No. EL/4.2.15

Dated 25.10.2013

MODIFICATION SHEET NO. RDSO/2012/EL/MS/0421 Rev '1'

Modification of loco control circuit for LSDBR lamp to avoid wrong indication of working of AC MVRF in MPCS fitted Electric Locomotives.

SKEL-4886 Alt-1

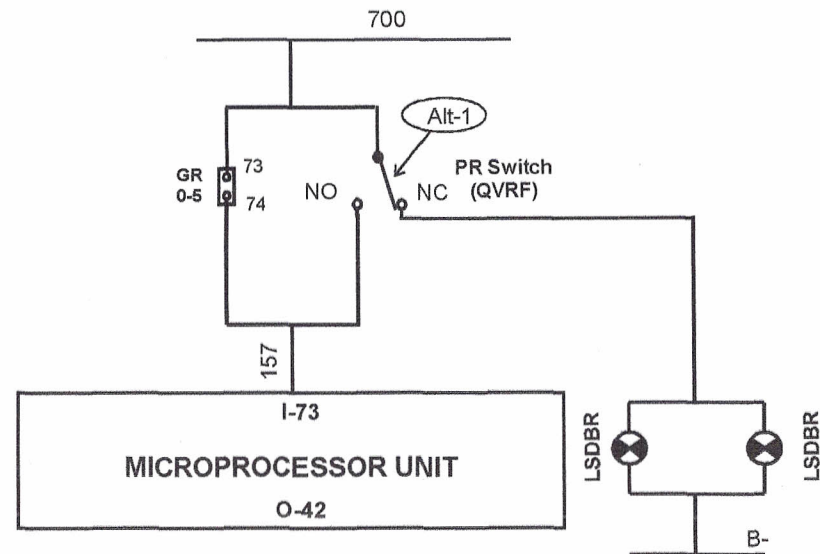
Electric Loco Shed BNDM/SER observed in Rev-'0' of this MS, still there is a scope for wrong indication. While AC MVRF stops working at higher notch (above 5) , LSDBR will not get feed through QVRF's NC interlock as GR 0-5 interlock is open and there is indication of defects in MVRF.

In MPCS loco, LSDBR extinguishes, the moment MP is put on P because of incorrect realization of existing logic. Existing circuit is displayed at drawing no. SKEL-4886 Alt-1 where LSDBR lamp is controlled by MPCS output no. O-42 and wire no. 234 and control input I-73 with QVRF pressure switch. Even in the event of failure of MVRF above 5th notch, LSDBR glows, auto-regression takes place upto 5th notch and again LSDBR extinguishes.

To overcome the above problem, LSDBR lamp is now being directly controlled and gets the feed from wire no. 700, interlocks of QVRF and 0-5 interlock of SMGR as in conventional locomotives. It is a hardwired circuit without any software logic. as shown in modified control circuit as per drawing No. SKEL- 4886 Alt-1. In this circuit LSDBR lamp always glows through wire no. 234, 0-5 interlock of SMGR and NC interlock directly. Whenever QVRF picks up, NO closes and disconnects wire no. 234 from wire no. 700 and feed to LSDBR discontinues, extinguishing LSDBR. After 5th notch of SMGR, if QVRF doesn't pick up because of any defect in MVRF or inadequate air flow, feed to the LSDBR ceases, extinguishing the same. This will be correct indication to locomotive crew about function of MVRF as available in non-MPCS fitted locomotives.

As per modified arrangement , wire no. 234 of LSDBR lamp should be removed from output O-42 side and connect to NC inter lock of QVRF pressure switch as shown in modified control circuit as per drawing No. SKEL- 4886 alt-1. Following work has to be carried out in this Rev-'1':

- i) Common terminal of QVRF to be connected to 700 cables directly.
- ii) NC terminal of QVRF to be connected to LSDBR.
- iii) NO terminal of QVRF to be connected to I-73 (Cable No. 157).
